**AGENDA**  
**PLANNING COMMISSION**  
**116 WEST NEEDLES**  
**BIXBY, OKLAHOMA**  
**February 18, 2014**                      **6:00 PM**

**To:** Bixby Planning Commission  
**From:** Erik Enyart, AICP, City Planner  
**Date:** Thursday, January 02, 2014  
**RE:** Report and Recommendations for:  
Preliminary Plat of “Quail Creek Office Park” (PUD 76)

**To:** Bixby Planning Commission  
**From:** Erik Enyart, AICP, City Planner  
**Date:** Wednesday, January 08, 2014  
**RE:** Report and Recommendations for:  
BSP 2013-06 – “Covenant Place of Tulsa” – Tanner Consulting, LLC (PUD 76)

**EXHIBIT A**  
**CONCEPTUAL SITE PLAN**

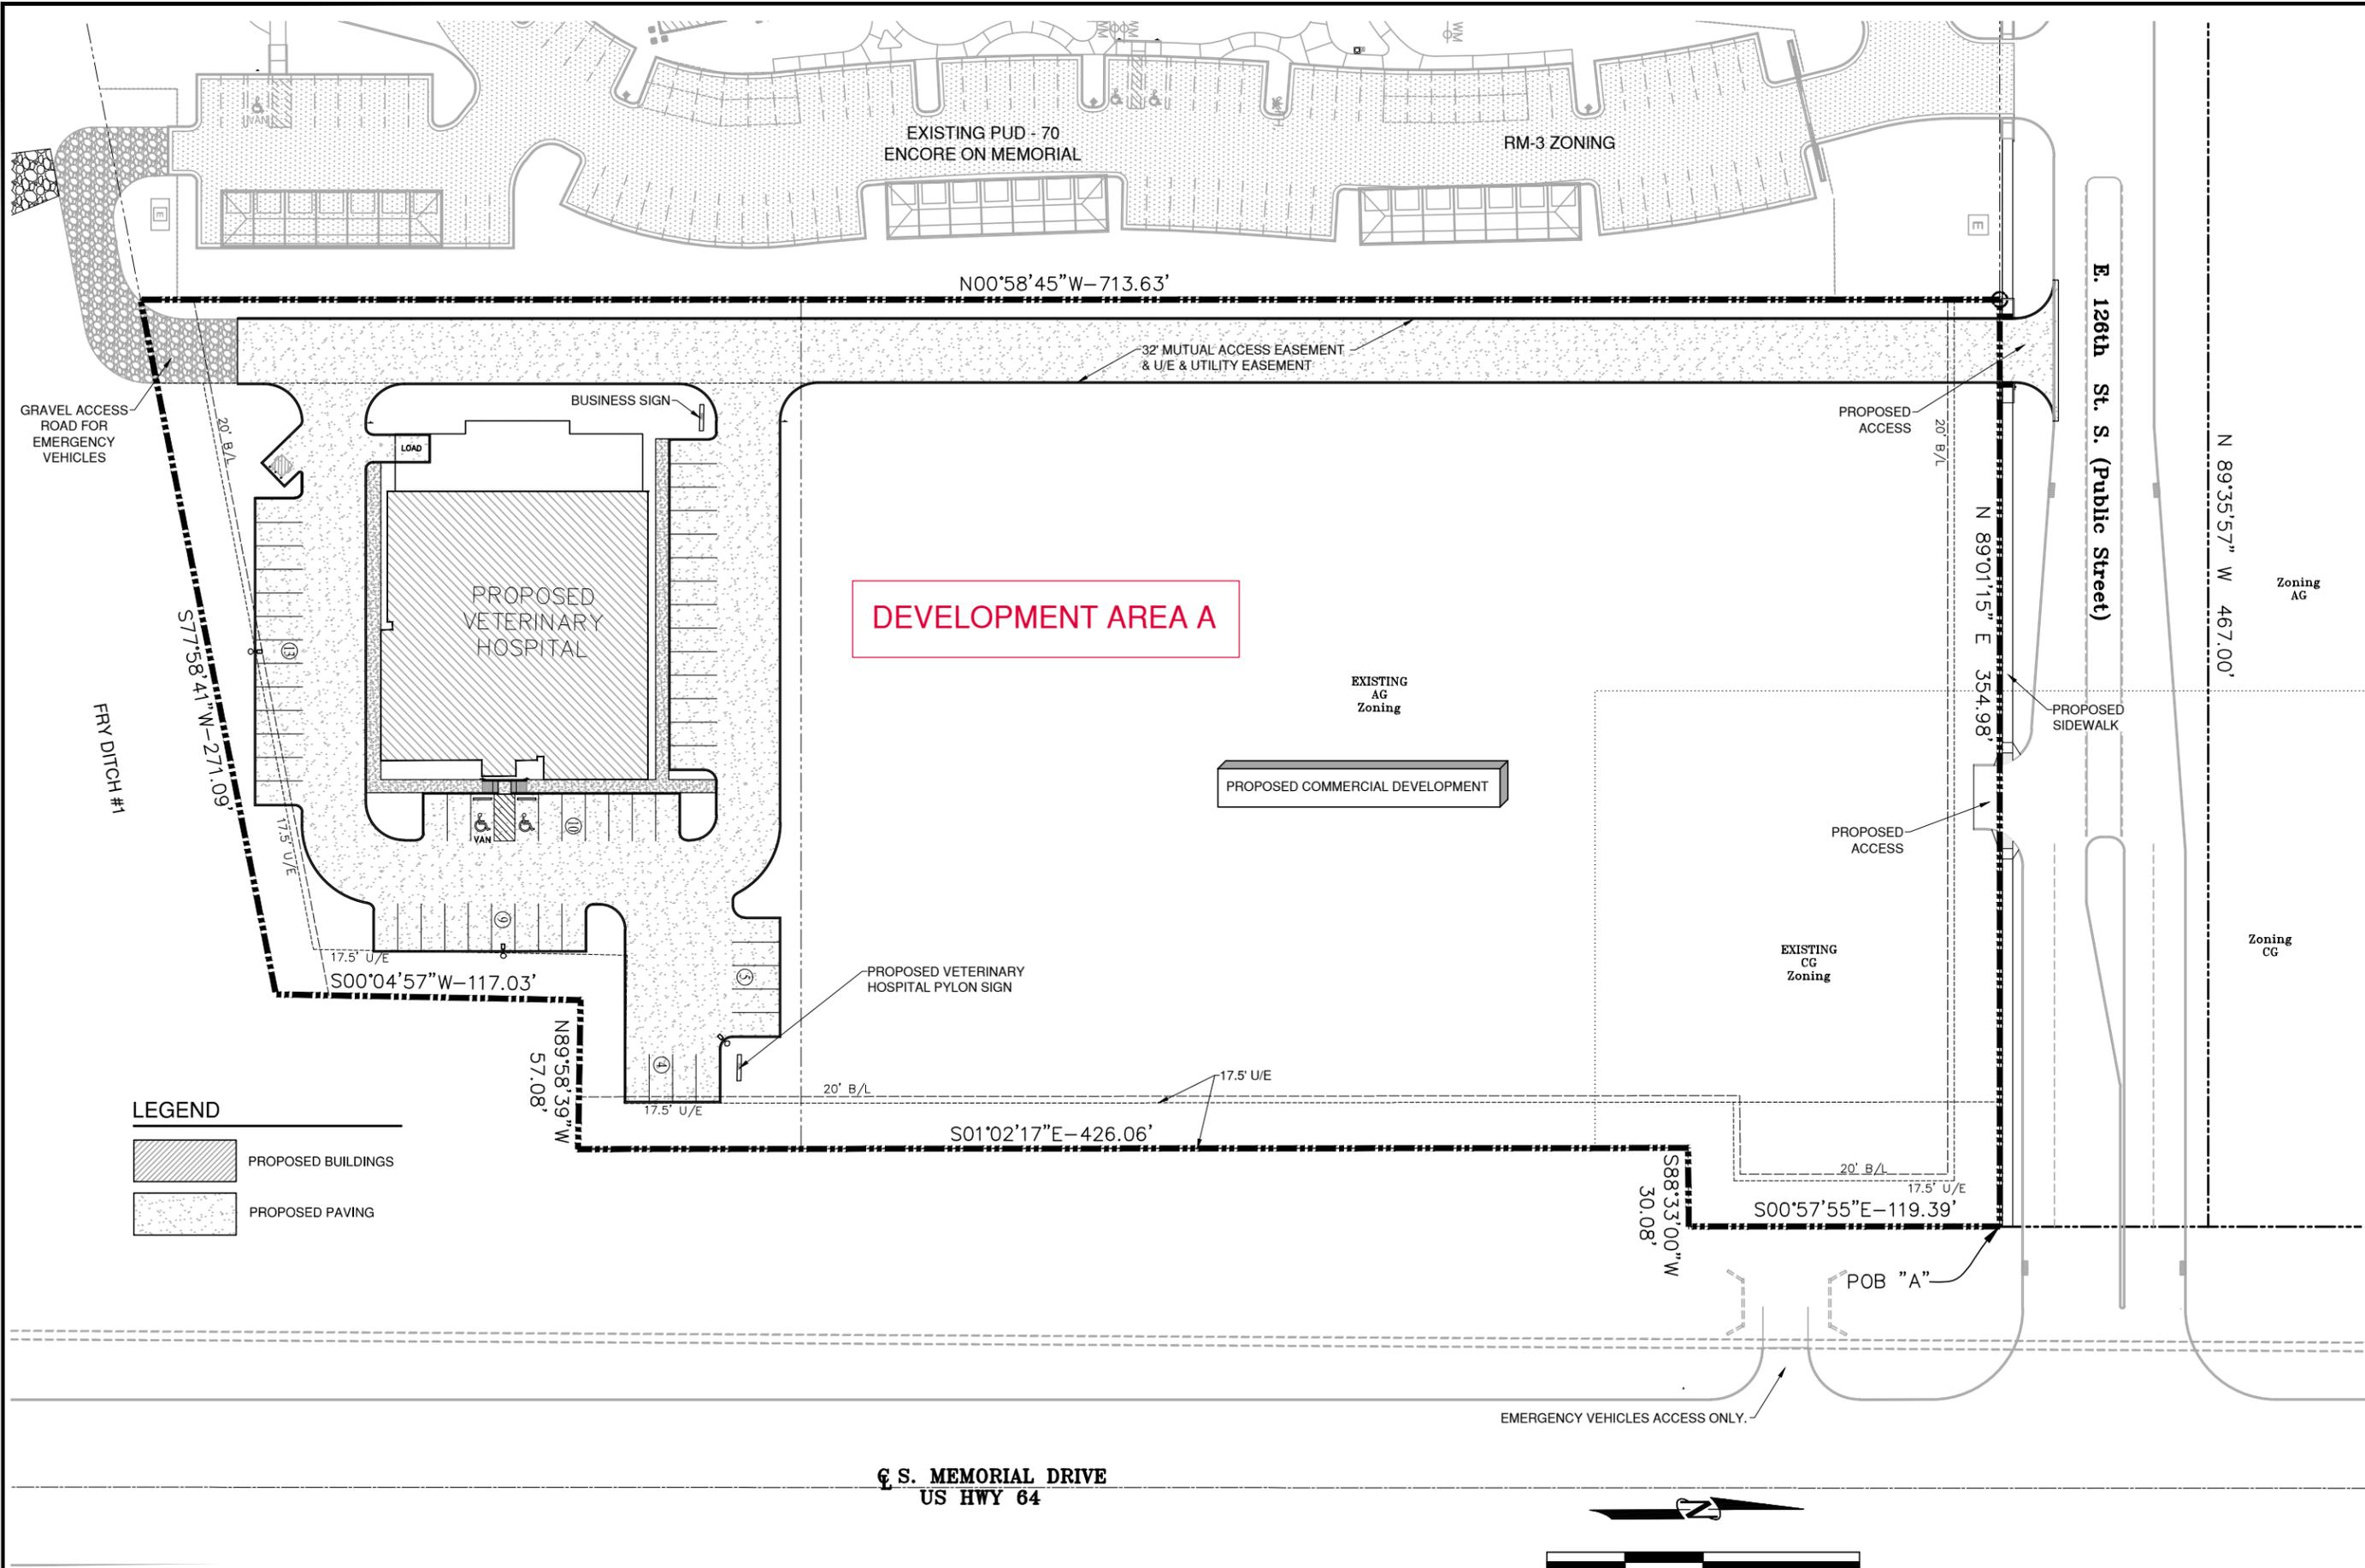
4. Only service taps for the proposed Clinic are shown. Any anticipated sewer line extensions for Area "A" should be shown on the Plans.
